## 36C26322R0040 Correct Isolation Room Issues (437-21-170)

### Questions and Responses

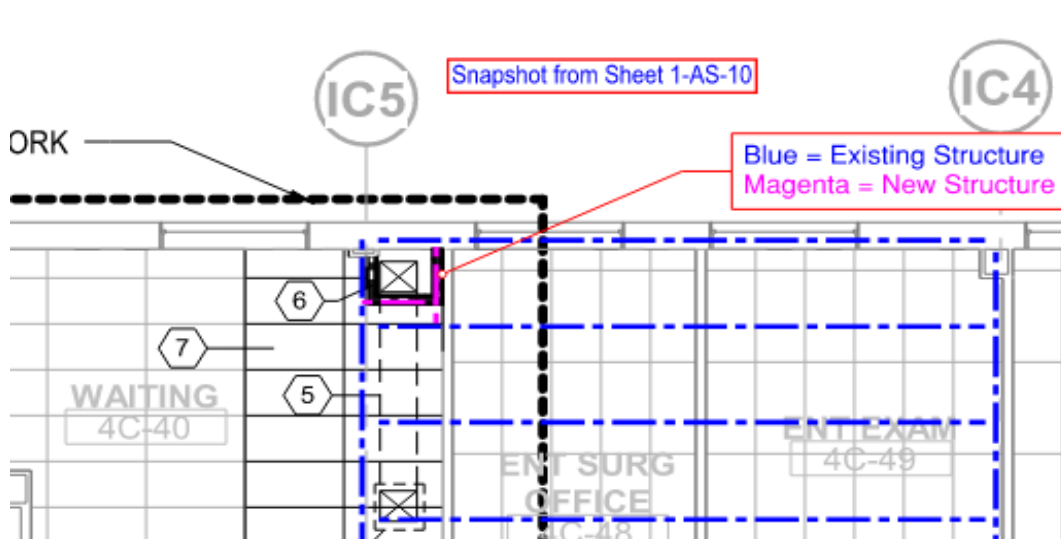
**Question:** 6 - Ref drawing 1-AS-11

Ref drawing 1-AS-11 - Will a specification be provided for the spray applied fireproofing required on new structural steel?

Yes and SFRM (Applied Fire Proofing 07 81 00) specification is attached.

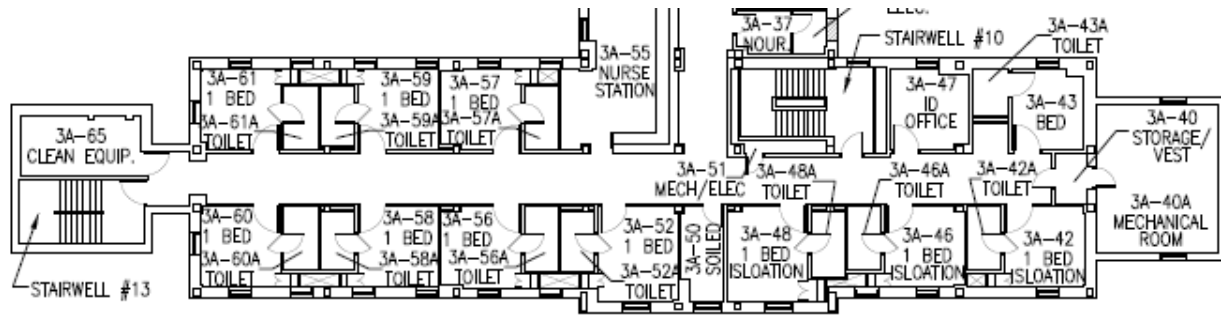
**Question:** 8 - Ref drawing 1-AS-12

Ref drawing 1-AS-12 - Will ICU rooms 3C-53 and 3C-54 be added to the room finish schedule?

No - Besides a new ceiling no other new finishes shall be needed in these rooms.

The image below shows the correct room numbers for the 3-Main rooms being worked on under this project for all trades and drawings under this contract.

At a minimum, plans where the wrong room numbers have been indicated on the drawing set:

- Detail 1 / 1-AS-11
- Room Finish Schedule on drawing 1-AS-12
- Detail 1 / E-7
